14-05 Adopt Interim Approval issued by the FHWA for Optional Use of a Bicycle Signal Face (1A-16)

Subject	Request for CTCDC Agenda Item: Bicycle Signal Faces	Date	8/12/2014
To	Devinder Singh, Executive Secretary California Traffic Control Devices Committee (CTCDC)

Joint BTC/STC #1
With California changes indicated in green

TECHNICAL COMMITTEE:	Bicycle Technical Committee and Signals Technical Committee
TOPIC:	Recommendation – Bicycle Signal Faces
STATUS/DATE OF ACTION:	Recommended to send to sponsors following the January 2014 NCUTCD meeting
Technical Committee Vote:	BTC – 19-1-0 STC – 35-0-0
Transmitted to Sponsors:	March 2014
Council Approval:	June 28, 2014
ORIGIN OF REQUEST:	Various
AFFECTED SECTIONS OF MUTCD:	Various portions of Parts 1, 4, & 9

Figure xx-1

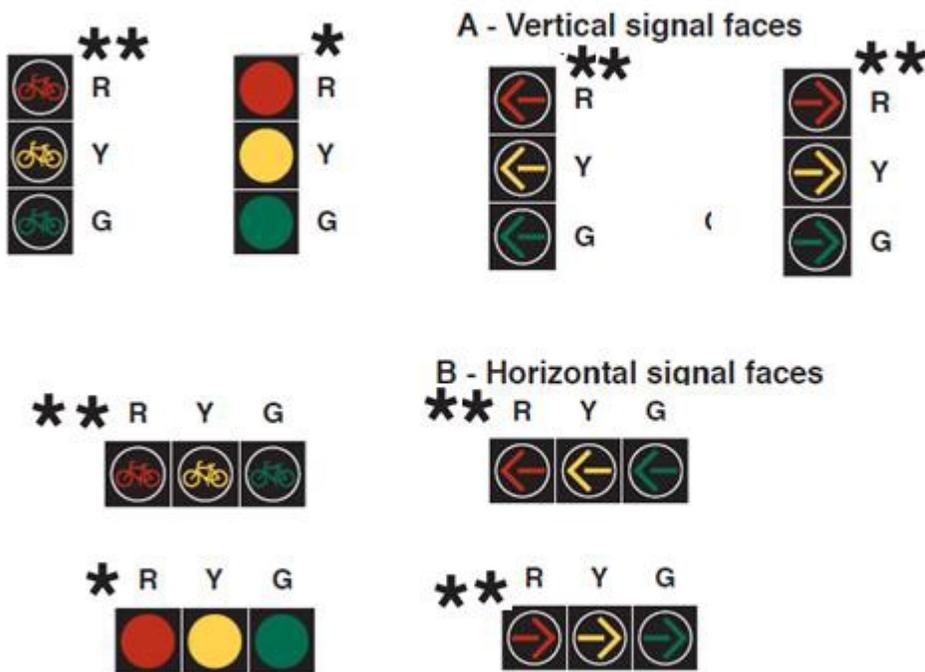
<BEGIN NCUTCD CONTENT NEEDING EDIT CORRECTION>

Support:

See Figures XX-1 and XX-2 for typical arrangements of signal sections in bicycle signal faces.

<BEGIN REPLACEMENT CONTENT WITH EDIT CORRECTION>

Support:

See Figure XX-1 for typical arrangements of signal sections in bicycle signal faces.
